November 1, 2023

**WHITE PLAINS CITY SCHOOL DISTRICT
AC AND VENTILATION UPGRADES AT
MAMARONECK AVENUE ELEMENTARY SCHOOL
SED Control Number: 66-22-00-01-0-010-017**

**CONTRACT H- HVAC WORK
CONTRACT E - ELECTRICAL WORK**

DRAWING No. **MD100.00**

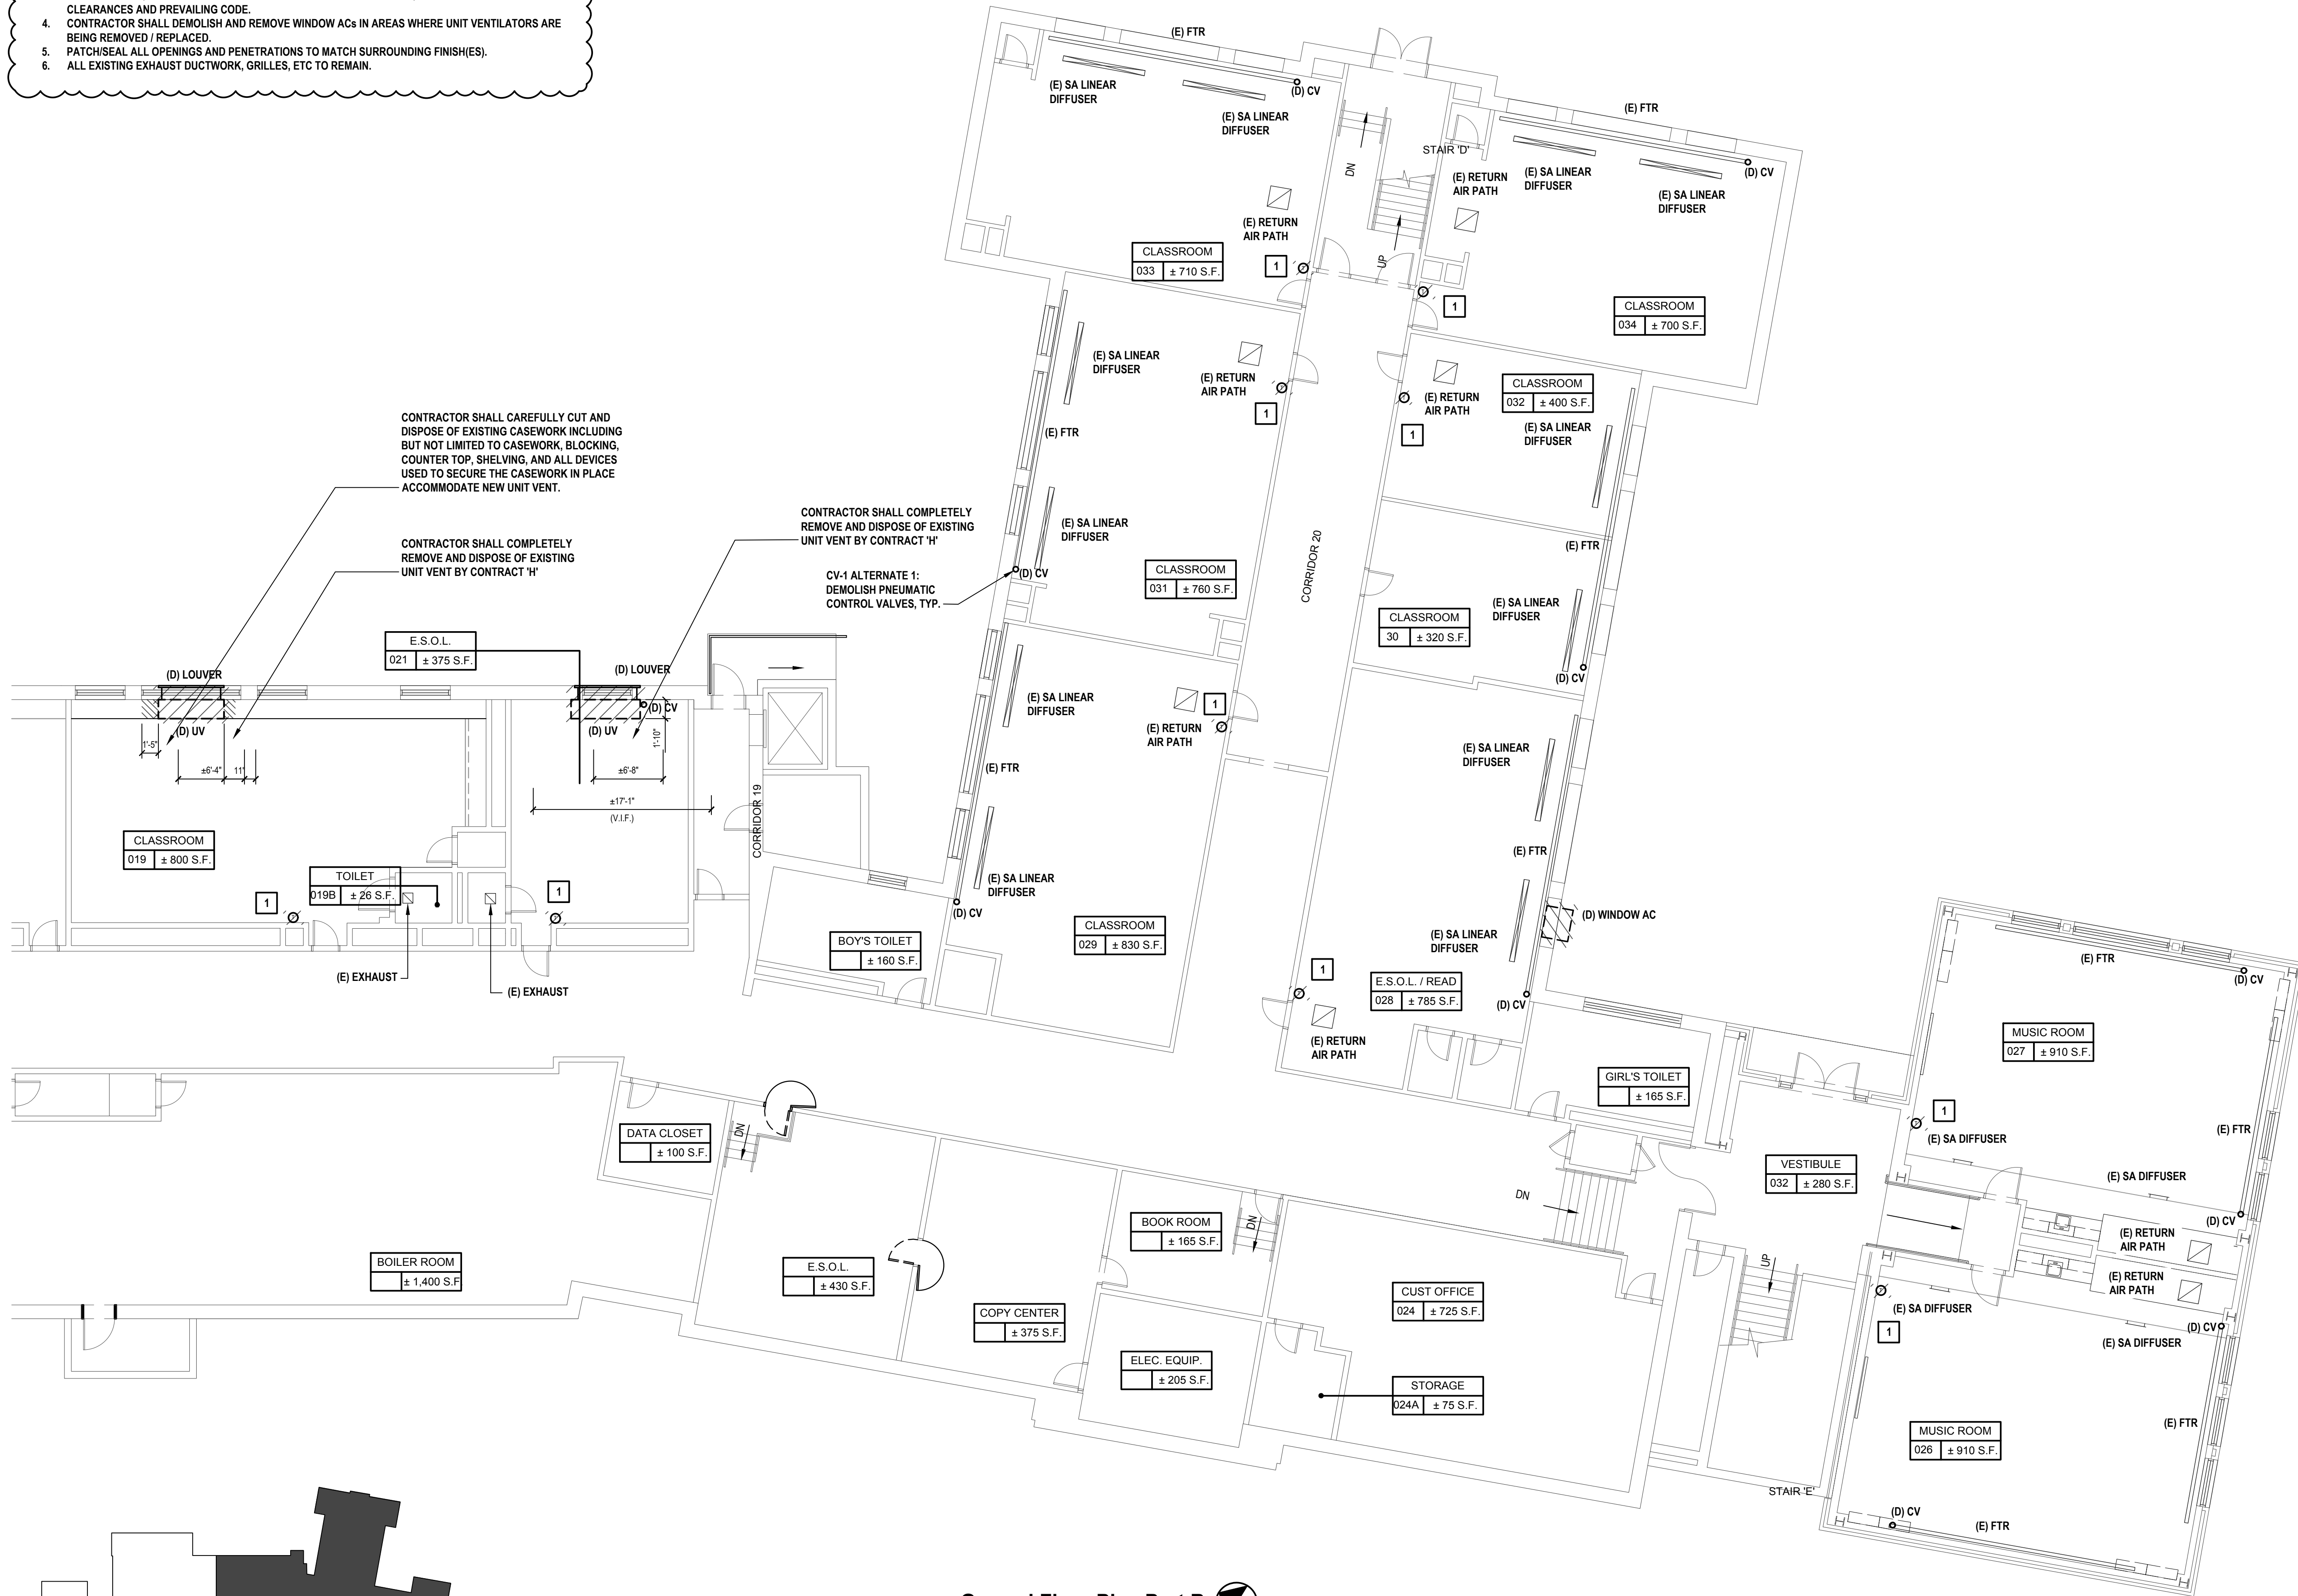
6. REMOVE DRAWING MD100.00 MECHANICAL GROUND FLOOR PLAN PART A AND REPLACE WITH REVISED DRAWING MD100.00 MECHANICAL GROUND FLOOR PLAN PART A. attached herewith. Please note that this drawing has been revised to clarify scope for the chase work, and mechanical work.

1. Dwg M001.00 "Add Alt. #1" states to provide a "new" two stage thermostat in lieu of the "new" single stage thermostat as shown on plans. Dwg MD100.00 "Note #1" states that these thermostats are to remain as part of the base bid. Please clarify how single stage thermostats are to be installed (I'm assuming part of the base bid) if the thermostats are not being removed as part of the base bid? Should there be an additional Add Alt. associated with this work? (1) Alt. to remove and replace with single stage and (1) Alt. to remove and replace with two-stage? Please advise.

RFI response: Base bid: Single stage hot water or steam heating thermostats to remain. Cooling thermostats for new UVs or VRF to be added.

1 THERMOSTAT TO BE DEMOLISHED AS PART OF ADD ALT 1. SEE SHEET M001.
THERMOSTAT TO REMAIN AS PART OF BASE SCOPE

DRAWING No.
MD101.00

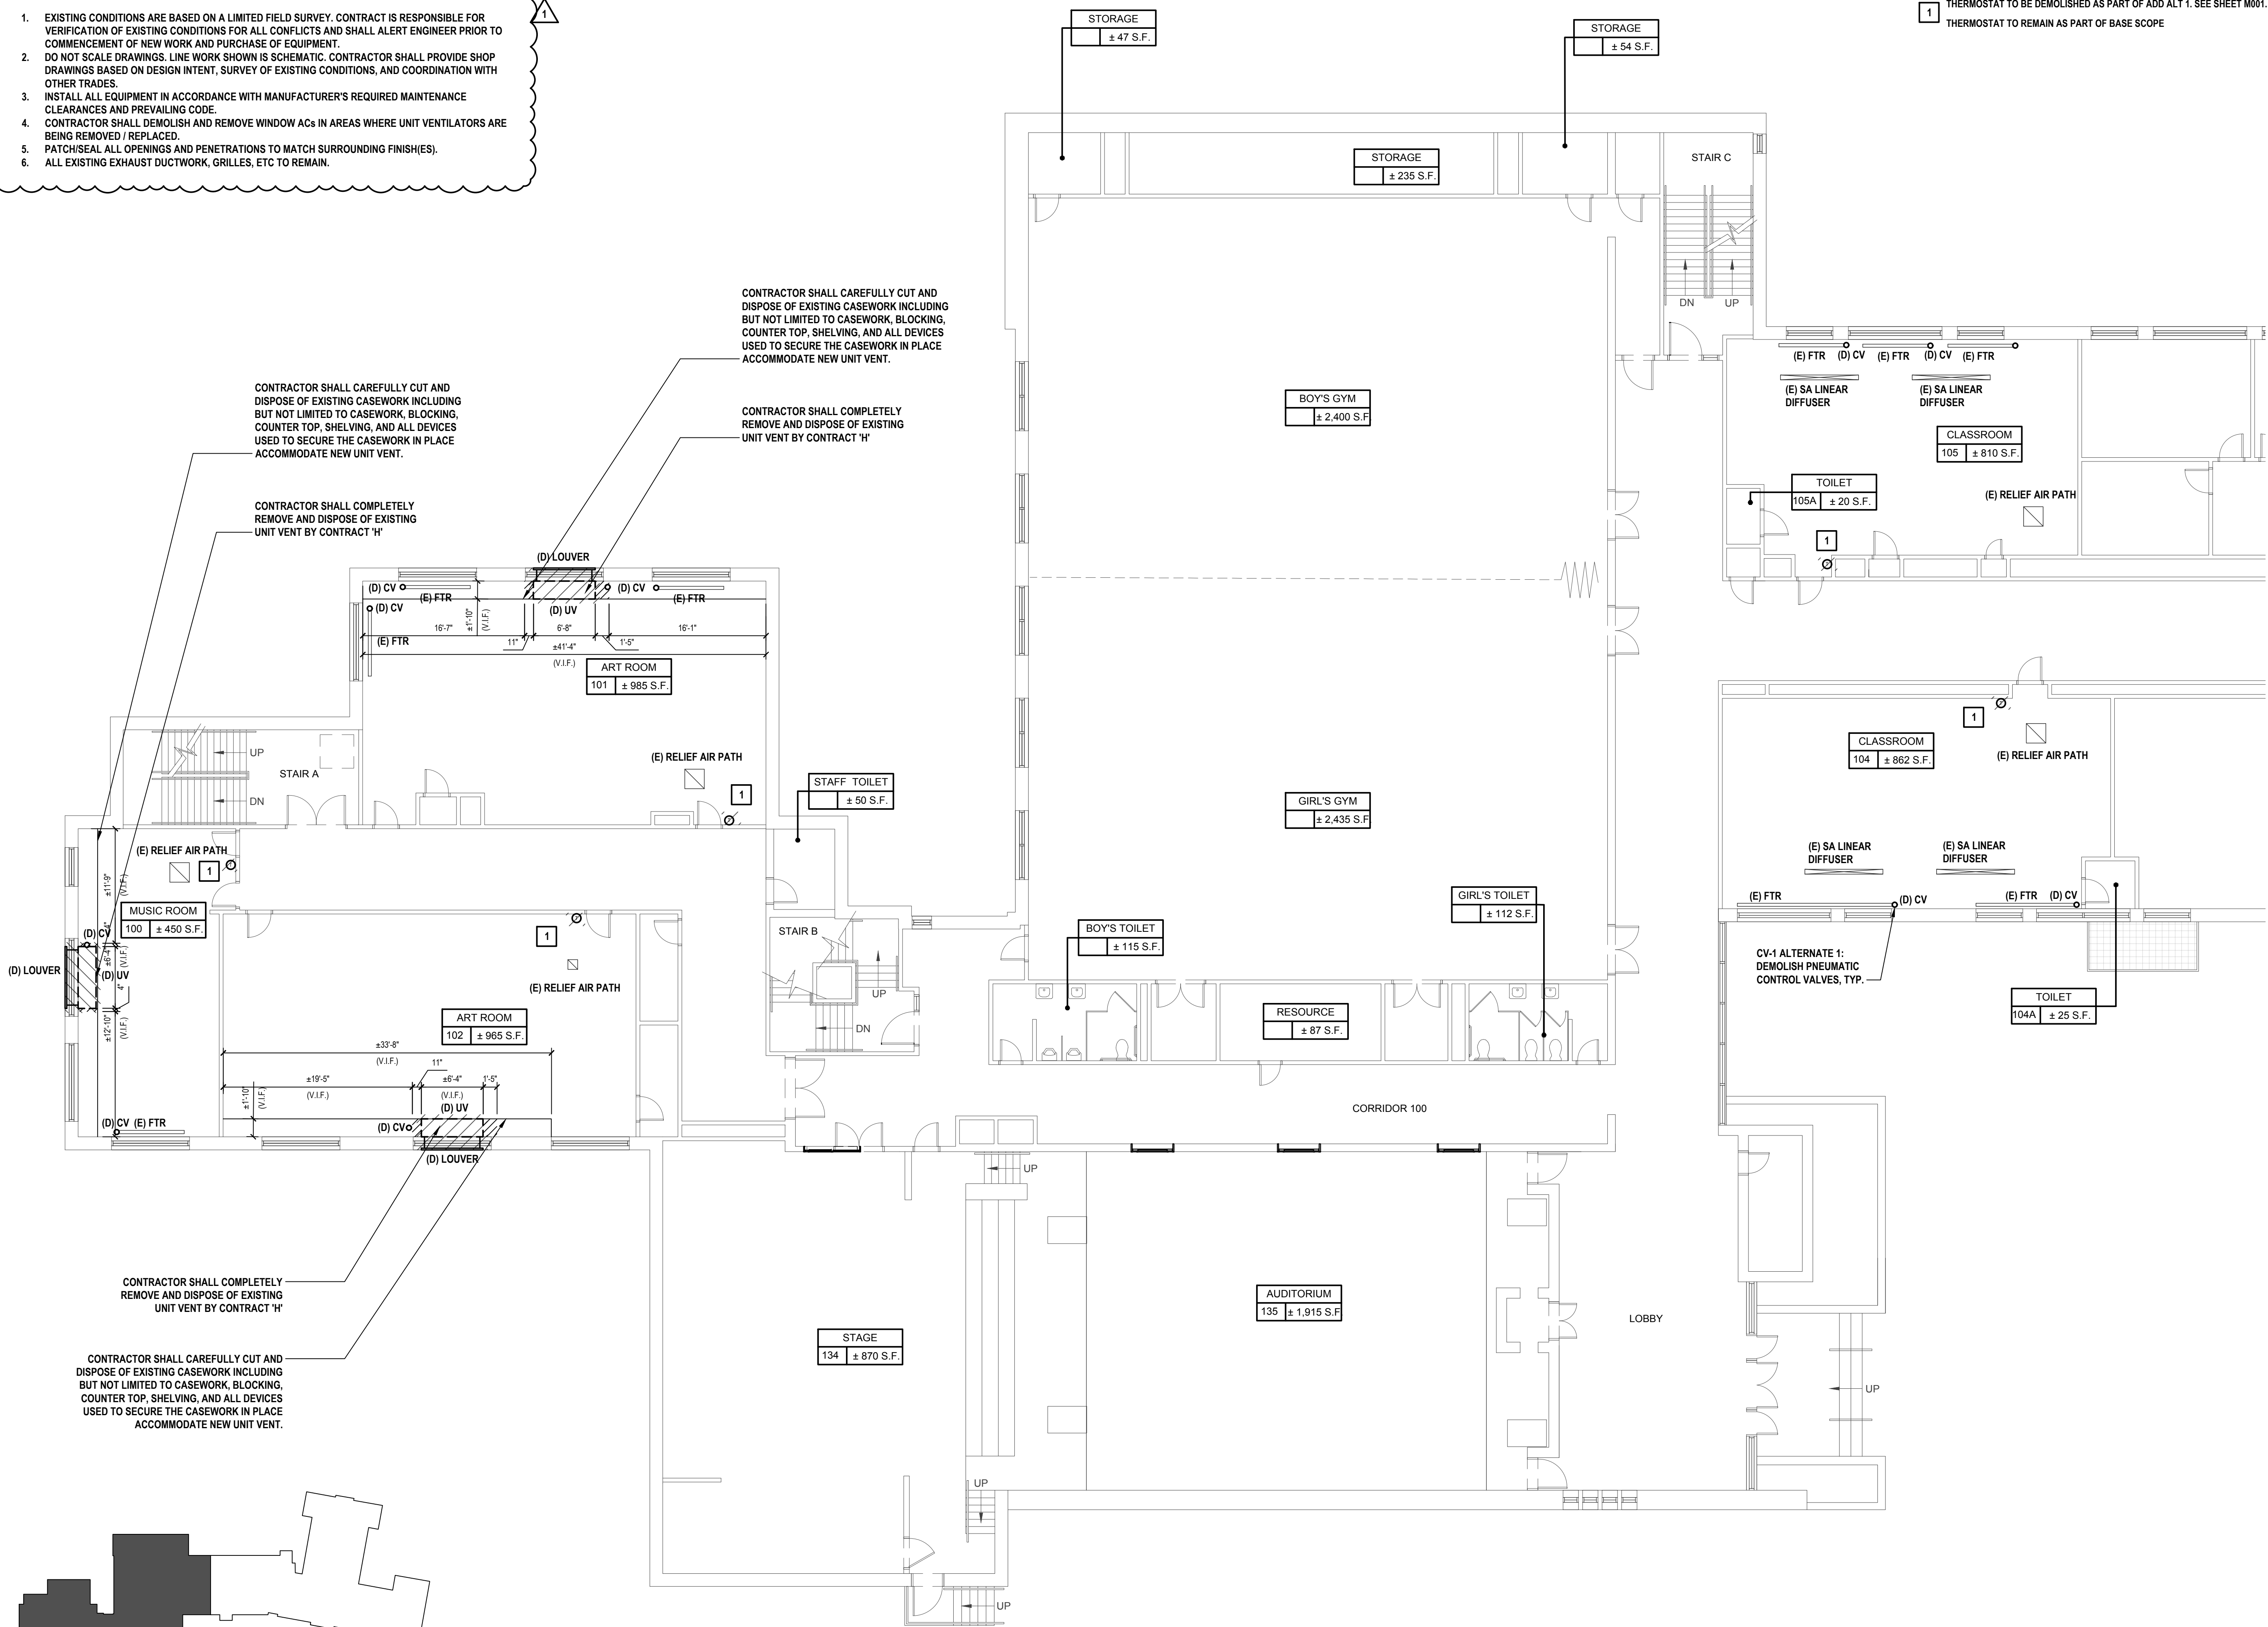
7. REMOVE DRAWING MD101.00 MECHANICAL GROUND FLOOR PLAN PART B AND REPLACE WITH REVISED DRAWING MD101.00 MECHANICAL GROUND FLOOR PLAN PART B. attached herewith. Please note that this drawing has been revised to clarify scope for the chase work, and mechanical work.

- KEYED NOTES:
- 1 THERMOSTAT TO BE DEMOLISHED AS PART OF ADD ALT 1. SEE SHEET M001.
THERMOSTAT TO REMAIN AS PART OF BASE SCOPE
